# Access Compliance Report

### (Curb Ramps)

Intersection ID: 9565	Main Street: N_TRYON_ST	Cross Street: W_32ND_ST	Location: SW
ADA ID: 6981113B6FF0	Ramp Type: PerpDiag	Initial Pass/Fail: Fail	Overall Compliance: No
Codes/Mitigation Info/Possible Solution			Severity Score: 35
			Field Measurements/Component Compliance

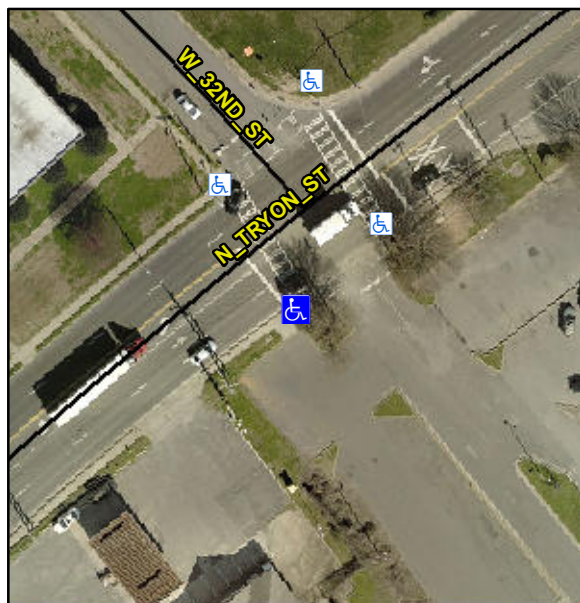
**Not Found, R304.5.1, R304.2.2, R304.5.3**

Compliance	Description	Data	Compliance	Description	Data
N/A	Ramp Length (in)	59.5	No	Ramp Slope (%)	15.6
No	Ramp Width (in)	46.0	No	Ramp XSlope (%)	4.5
N/A	Flare Type LT	N/A	N/A	Flare Type RT	N/A
N/A	Flare Slope LT (%)	N/A	N/A	Flare Slope RT (%)	N/A
N/A	Flare Traversable LT?	N/A	N/A	Flare Traversable RT?	N/A
N/A	Landing Length (in)	N/A	N/A	DWS Provided?	N/A
N/A	Landing Width (in)	N/A	N/A	DWS Contrast?	N/A
N/A	Landing Slope (%)	N/A	N/A	DWS Length (in)	N/A
N/A	Landing X Slope (%)	N/A	N/A	DWS Full Width?	N/A
N/A	Landing Curb? (Y/N)	N/A	N/A	DWS Offset (in)	N/A
N/A	Shared Landing?	N/A			
N/A	Gutter Ponding?	Yes	N/A	Gutter Slope (%)	N/A
N/A	Gutter Lip Ht (in)	N/A	N/A	Gutter X Slope (%)	N/A
N/A	Painted X Walk1?	Yes	N/A	Painted X Walk2?	Yes
	X Walk 1 Direction	To NE		X Walk 2 Direction	To NW
N/A	X Walk 1 Width (in)	111.0	N/A	X Walk 2 Width (in)	107.0
	X Walk 1 Slope (%)	1.6		X Walk 2 Slope (%)	3.6
	X Walk 1 X Slope (%)	3.4		X Walk 2 X Slope (%)	0.7

**Remove & Replace Curb Ramp With Two New Directional Ramps or Equivalent.**
